CITY OF VANCOUVER
COMMUNITY SERVICES GROUP

DEVELOPMENT PERMIT STAFF COMMITTEE REPORT
FEBRUARY 11, 2009

1258 WEST BROADWAY (PRELIMINARY APPLICATION)
DE412570 - ZONE C3-A

Figure 2

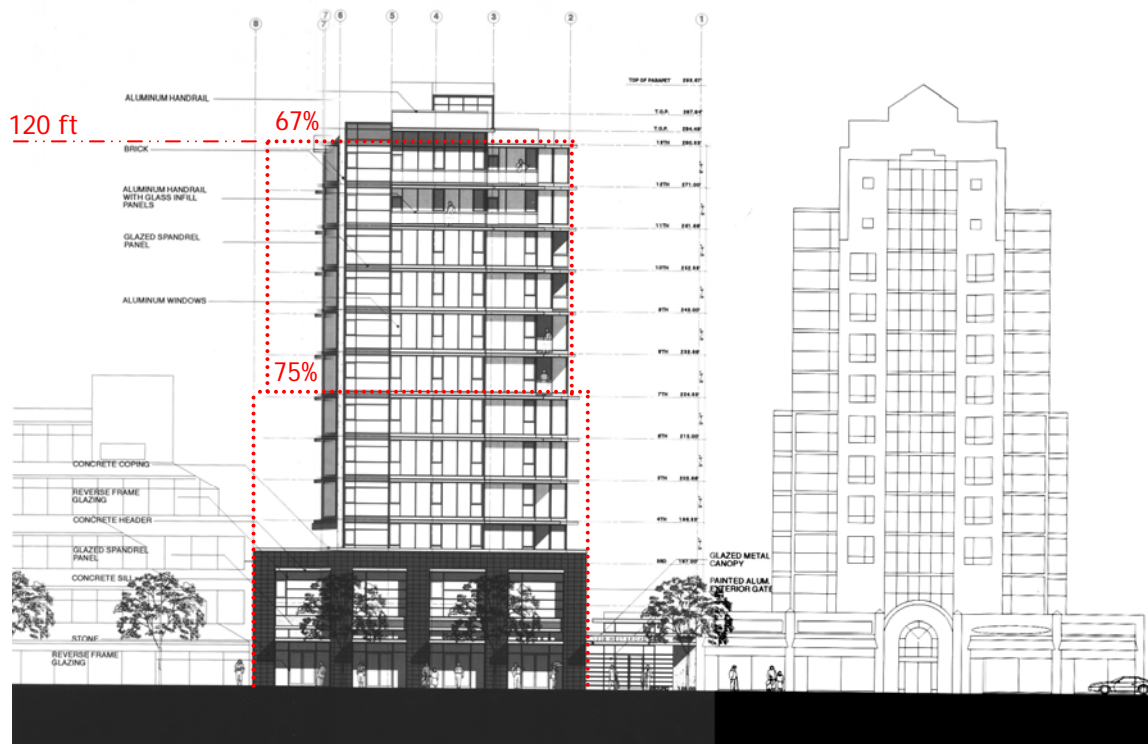
The requested increase in density, including an additional 10% of transferred heritage density, has been well handled and fits within the suggested massing of the Guidelines. Figure 2 shows a comparison between the proposed building and suggested Guideline massing. The proposed building is significantly thinner in both the mid-rise and high-rise portions of the building than what the Guidelines recommend, with a relatively small typical floor plate of 3,800 sq. ft. The slimmer massing has the positive effect of both reducing shadows on the street, and improving sun access and views through the site.

2ND FLOOR PLAN

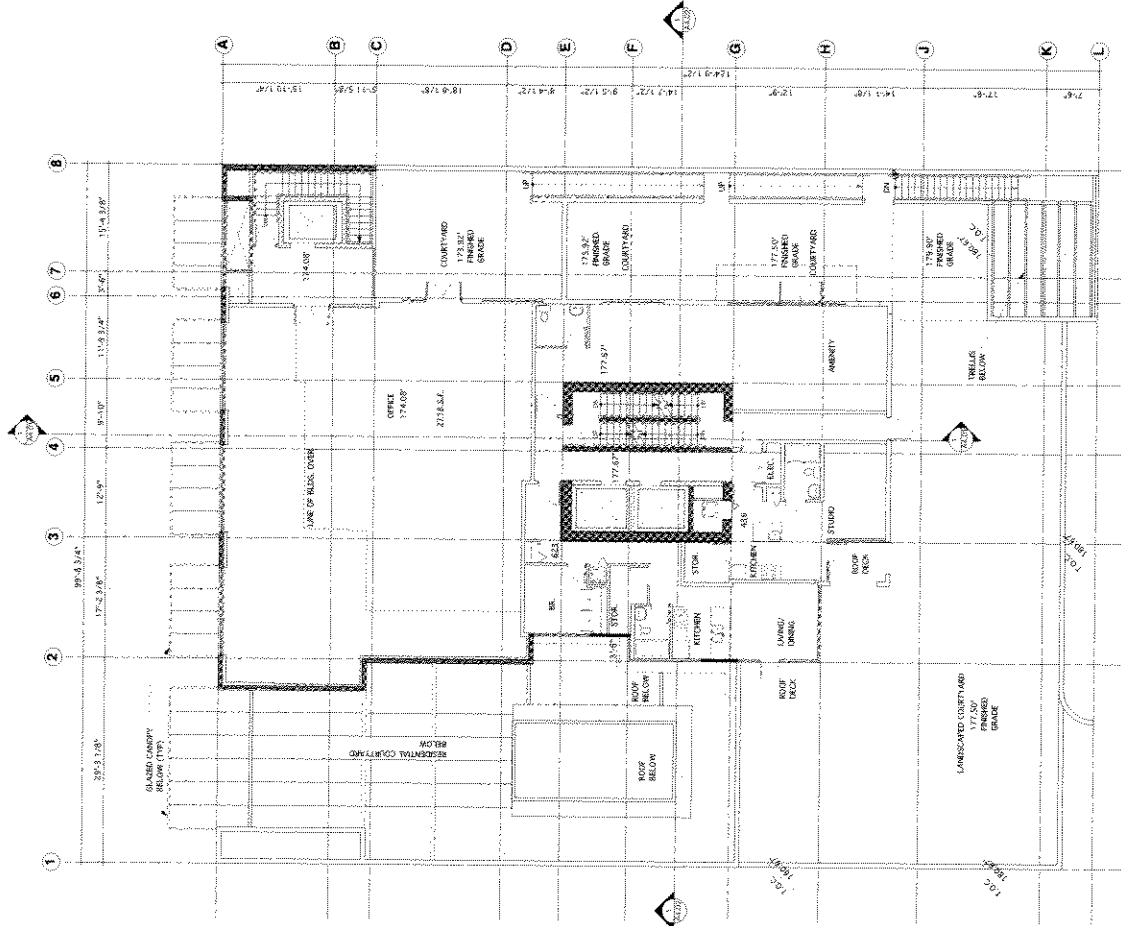
- *f) An exit is not permitted to exit through a loading bay.
 6. 2nd Floor: Handicap access is required to the southwest corner amenity landscaped courtyard (sheet L1 of 1).
-

WEST
ELEVATION

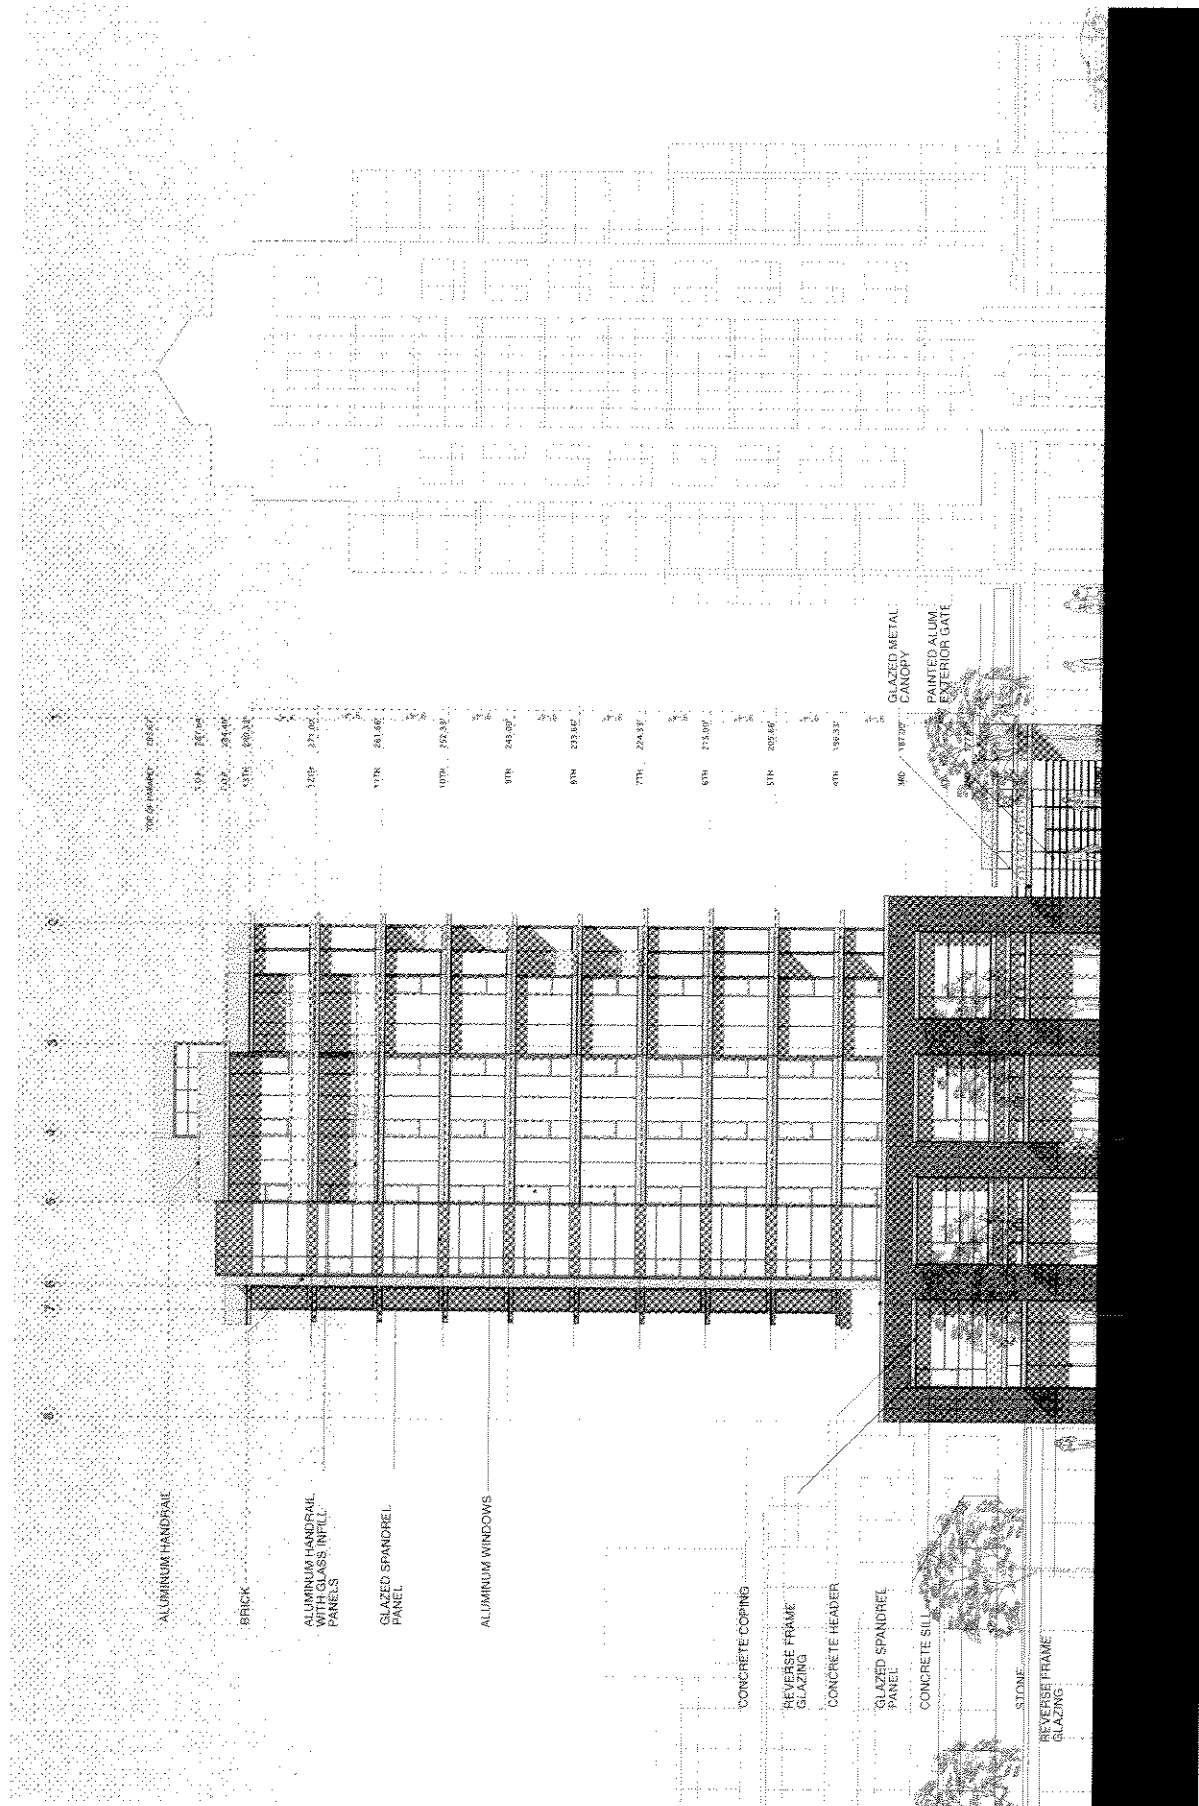
- 1.2 design development to the west elevation to limit overlook with the neighbouring building and improve solar response by reducing the amount of window area;

Note to Applicant: Consider the alternative use of more coloured spandrel panels to reduce the area of clear glazing without significant altering of the architectural expression.
